REFERRAL RESPONSE – URBAN DESIGN

FILE NO: Development Applications: DA376/2025/1

ADDRESS: 351 New South Head Road DOUBLE BAY 2028

PROPOSAL: Demolition of the existing building and construction of a new residential flat building including basement carpark with affordable housing

Figure 02: Approach to massing. Note: Drawings are diagrammatic only, and compliance with these diagrams does not suggest a development approval.

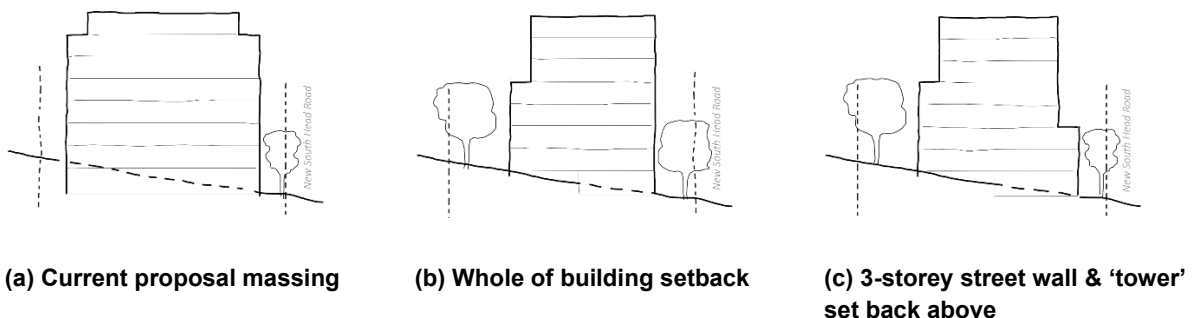
- Alternatively, a lower street wall datum of 3-storeys at New South Head Road that relates to surrounding development and tree line may be provided, and any floor above is to be set back at least 3 metres from the street wall (see Figure 2 below).
